RE: JMC Project 20044  
4 Tripp Lane Zoning Compliance  
4 Tripp Lane  
Town of North Castle, New York

**Response to KSCJ Comments Outlined in a Memorandum Issued to the  
Conservation Board & Planning Board, dated February 15, 2024.**

PEREIRA RESIDENCE

Drawn: DK	Approved: AN
Scale: 1" = 20'	
Date: 03/01/2021	
Project No: 20044	
2004-9E	CUT AND FILL
Drawing No: C-410	FILL PLANS

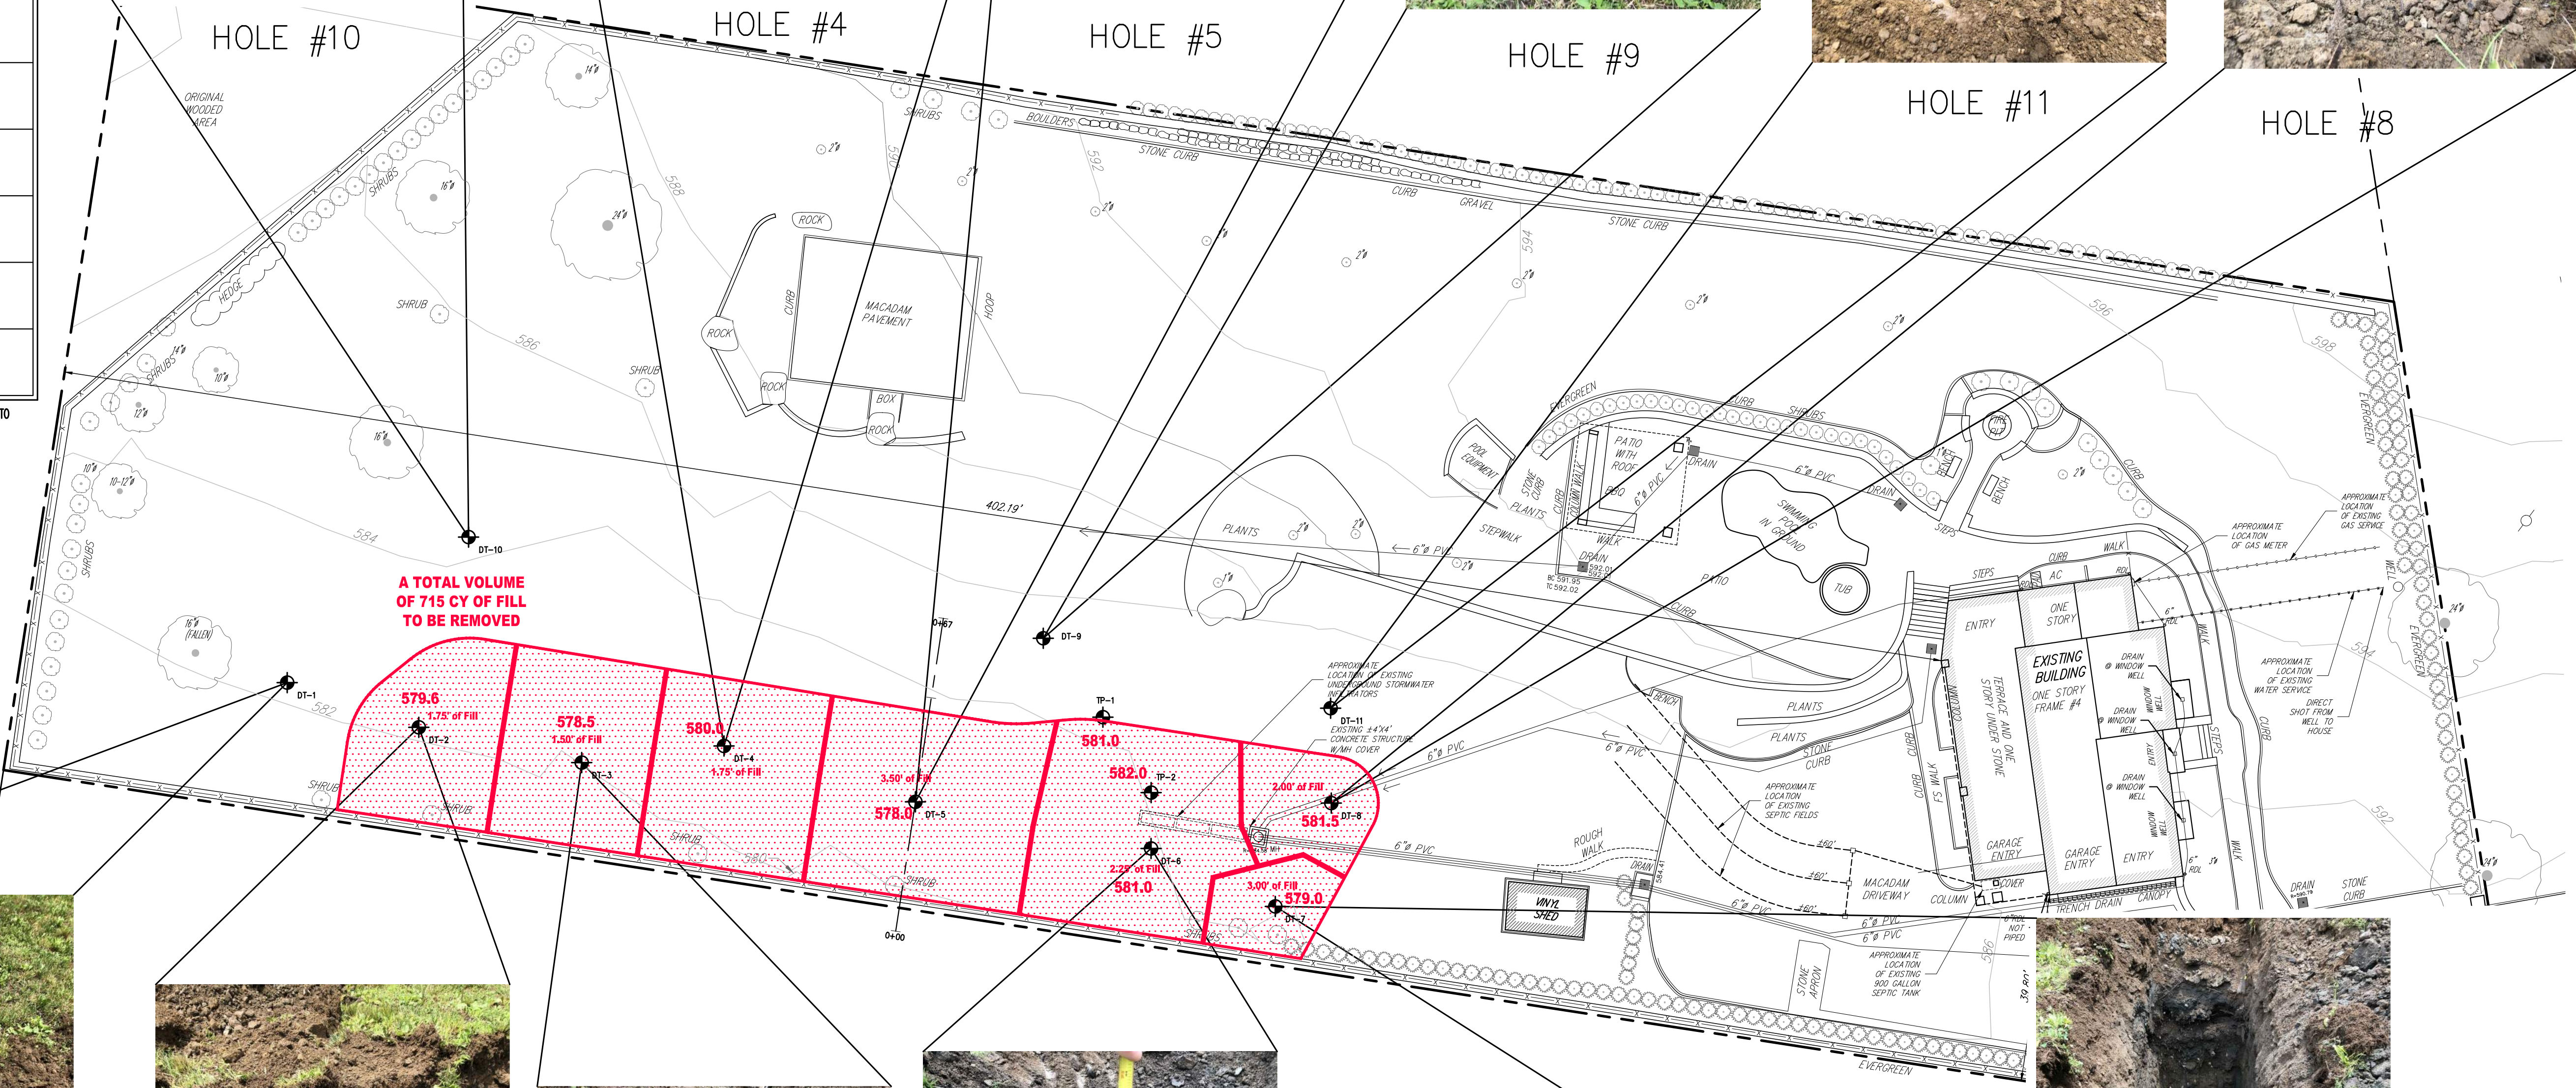
*As previously requested, the cut and fill plan should overlay the surveyed topography onto the pre-developed GIS topography to illustrate the cut and fill volumes established between pre-existing conditions and existing conditions. The fill sampling and testing was reviewed by the Town's Environmental Consultant. It was agreed that the fill remain in place with a 24 inch soil cap and a demarcation layer (orange fence or geotextile membrane) placed above the existing fill section. The soil cap shall include a minimum six (6) inch layer of top soil. This has been noted and detailed on the plan. However, the applicant shall prepare a proposed grading plan to illustrate how the add fill will be accommodated on the site and what, if any, added modifications to walls, walks, drives, etc., may be needed as a result. The applicant must also prepare an erosion and sediment control plan to illustrate and detail temporary access to the site and protection of the septic field for the import of clean fill, as well as all temporary sediment and erosion control measures that will be required.*
